SERVICE BULLETIN

N° **139-711**

**ATA 52 - PILOT HIGH VISIBILITY DOORS KIT INSTALLATION**

This Service Bulletin is issued in order to provide the necessary instruction on how to perform the installation of kit pilot high visibility doors P/N 4G5211F00111.

**4G5211F00111**  
**KIT PILOT HIGH VISIBILITY DOORS**

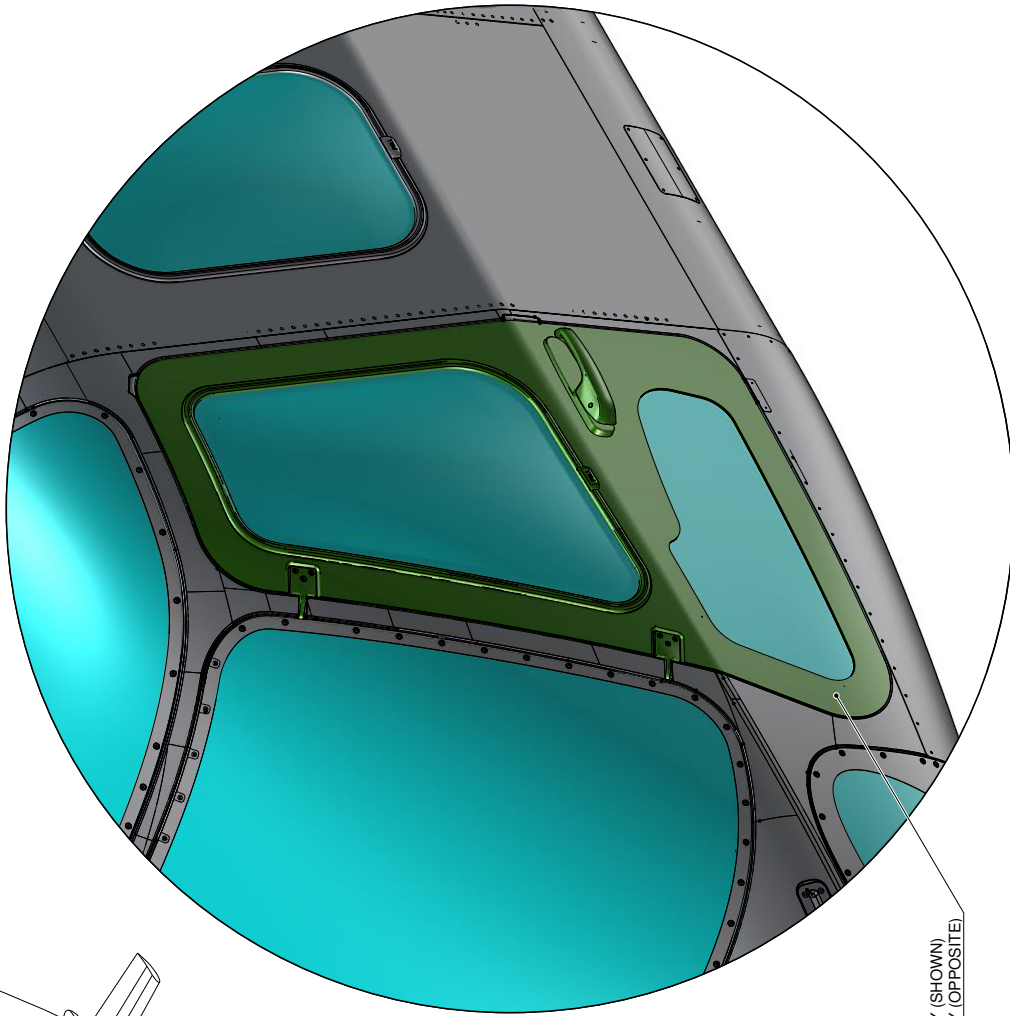
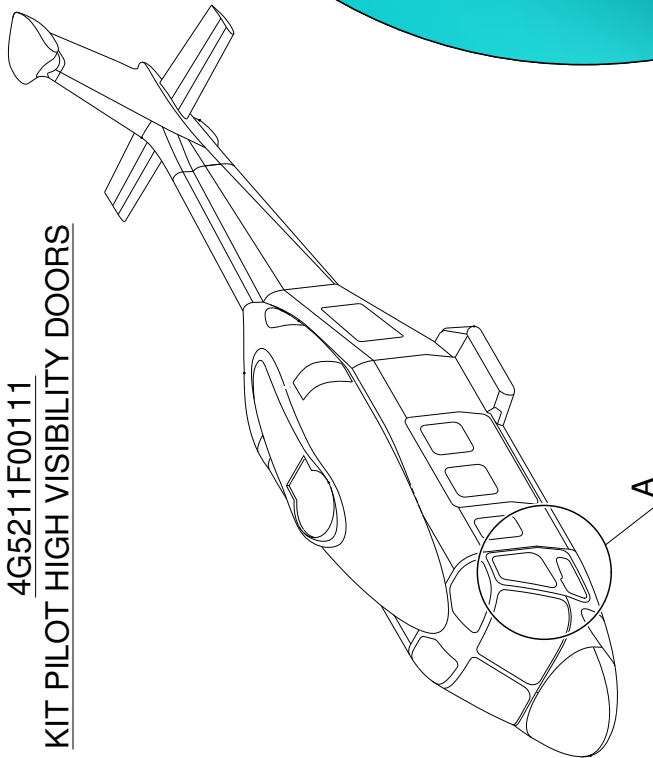
2. In accordance with DM 39-A-52-11-01-00A-520A-A and with reference to Figure 1, remove and discard the pilot door assy LH P/N 3P5211A00133 or subsequent. Retain fixing hardware for later re-use.

3. In accordance with DM 39-A-52-11-02-00A-520A-A and with reference to Figure 1, remove and discard the pilot door assy RH P/N 3P5211A00233 or subsequent. Retain fixing hardware for later re-use.

- REMOVE:  
 ⚠ 3P5211A00133 PILOT DOOR ASSY LH (SHOWN)  
 ⚠ 3P5211A00233 PILOT DOOR ASSY RH (OPPOSITE)  
 INSTALL:  
 3G5211A03232 PILOT DOOR ASSY LH HIGH VISIBILITY (SHOWN)  
 3G5211A03332 PILOT DOOR ASSY LH HIGH VISIBILITY (OPPOSITE)

4. In accordance with DM 39-A-52-11-01-00A-720A-A and with reference to Figure 1, install the pilot door assy LH high visibility P/N 3G5211A03232 by means of the previously removed hardware (Ref. step 2).

5. In accordance with DM 39-A-52-11-02-00A-720A-A and with reference to Figure 1, install the pilot door assy RH high visibility P/N 3G5211A03332 by means of the previously removed hardware (Ref. step 3).

**3G1130A05611**  
**PILOT/COPILOT HIGH VISIBILITY DOOR**  
**INTERNAL MARKINGS VARIANT**

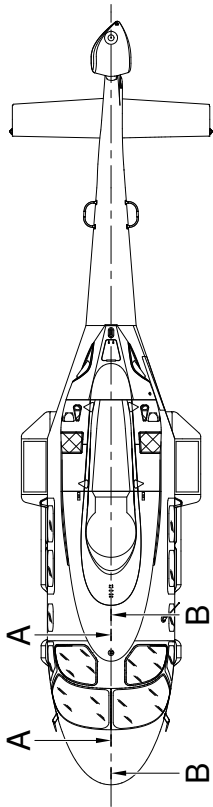
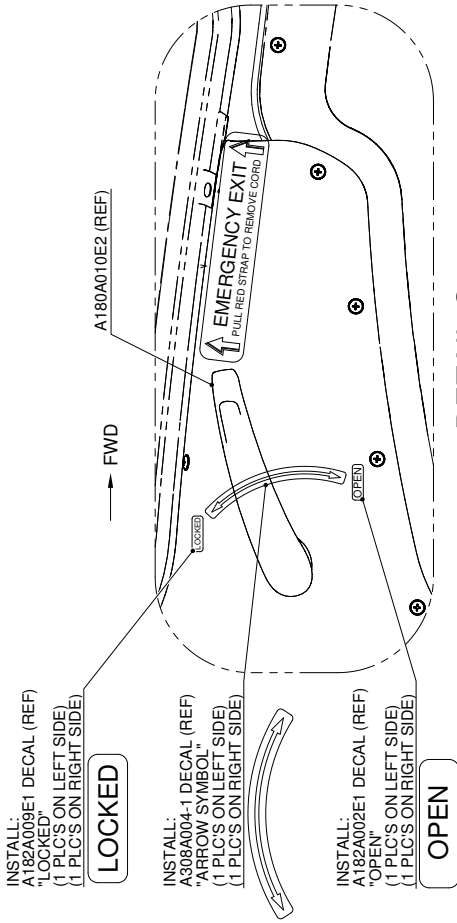
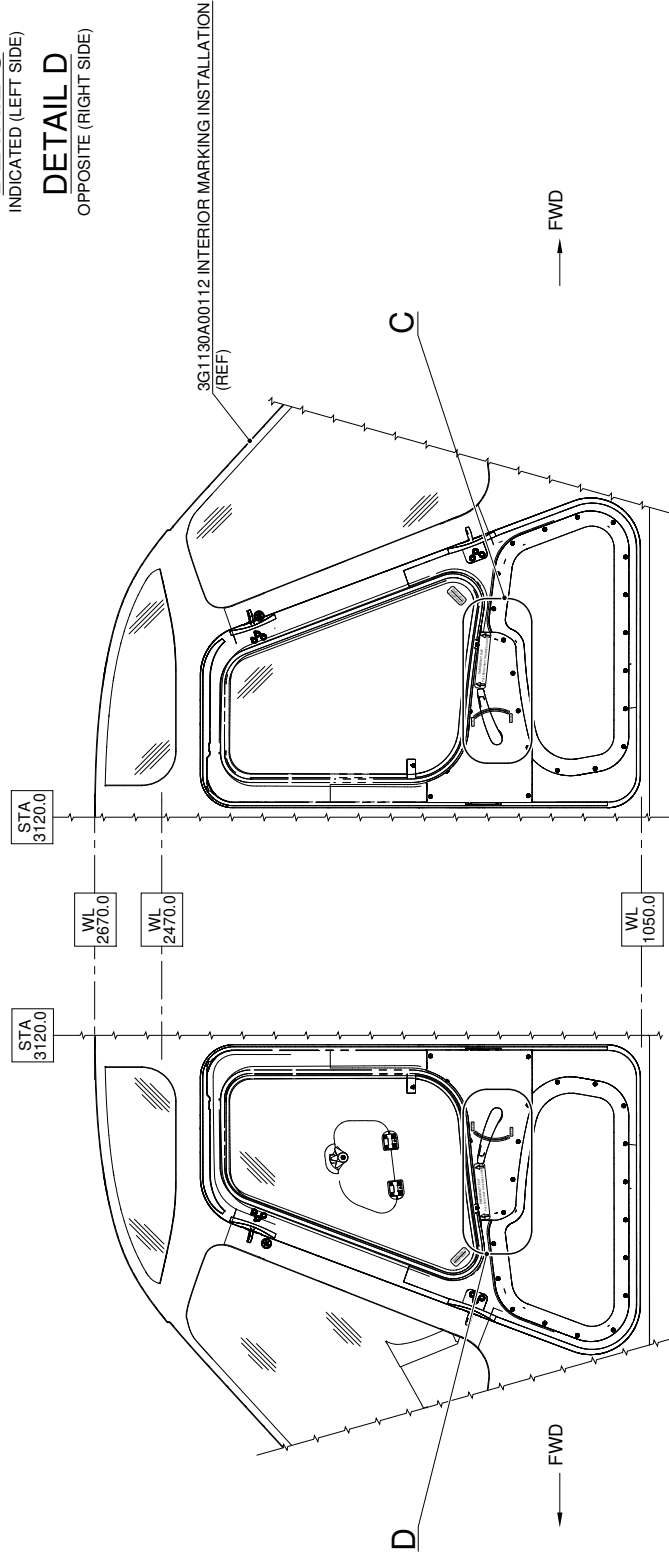
6. In accordance with DM 39-A-11-00-01-00A-720A-A and with reference to Figure 2, perform the pilot/copilot high visibility door internal markings variant P/N 3G1130A05611 as described in the following procedure:

- 6.1 Install the decals P/N A182A009E1, P/N A308A004-1, P/N A182A002E1 and P/N A180A010E2 in the indicated positions on the pilot door assy LH high visibility P/N 3G5211A03232.

- 6.2 Install the decal P/N A182A009E1, P/N A308A004-1, P/N A182A002E1 and P/N A180A010E2 in the indicated positions on the pilot door assy RH high visibility P/N 3G5211A03332.

**3G1120A05711**  
**PILOT/COPILOT HIGH VISIBILITY DOOR**  
**EXTERNAL MARKINGS VARIANT**

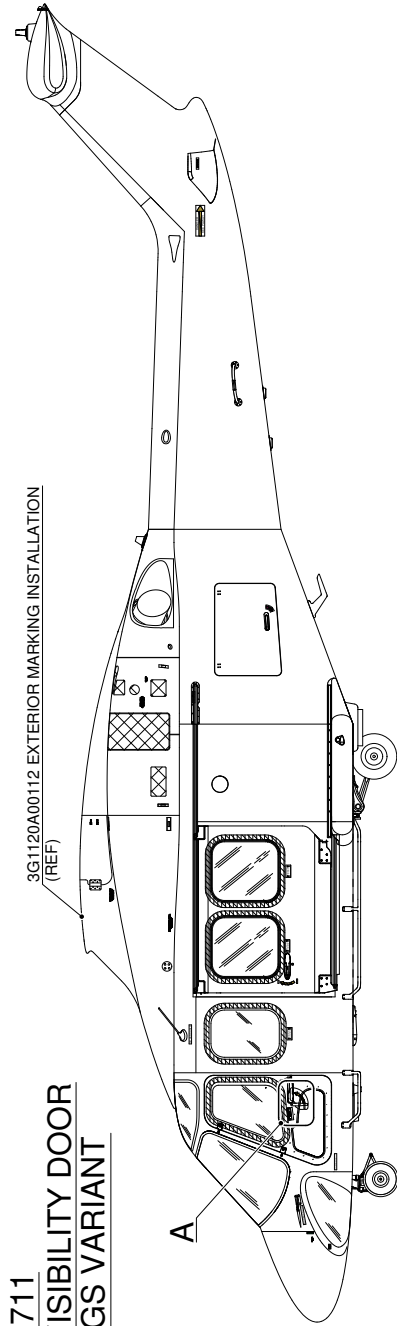
7. In accordance with DM 39-A-11-00-01-00A-720A-A and with reference to Figure 3,

perform the pilot/copilot high visibility door external markings variant P/N 3G1120A05711 as described in the following procedure:

- 7.1 Install the decals P/N A499AHO040E04N00 and P/N A499AHL100E04N00 in the indicated positions on the pilot door assy LH high visibility P/N 3G5211A03232.
- 7.2 Install the decal P/N A499AHO040E04N00 and P/N A499AHL100E04N00 in the indicated positions on the pilot door assy RH high visibility P/N 3G5211A03332.

- 7.3 Install the decals P/N A499AHO040E01N00 and P/N A499AHL100E01N00 in the indicated positions on the pilot door assy LH high visibility P/N 3G5211A03232.

- 7.4 Install the decal P/N A499AHO040E01N00 and P/N A499AHL100E01N00 in the indicated positions on the pilot door assy RH high visibility P/N 3G5211A03332.

- 7.5 Install the decals P/N A489A001 and P/N 212-072-636-109 in the indicated positions on the pilot door assy LH high visibility P/N 3G5211A03232.
- 7.6 Install the decals P/N A489A002 and P/N 212-072-636-109 in the indicated positions on the pilot door assy RH high visibility P/N 3G5211A03332.
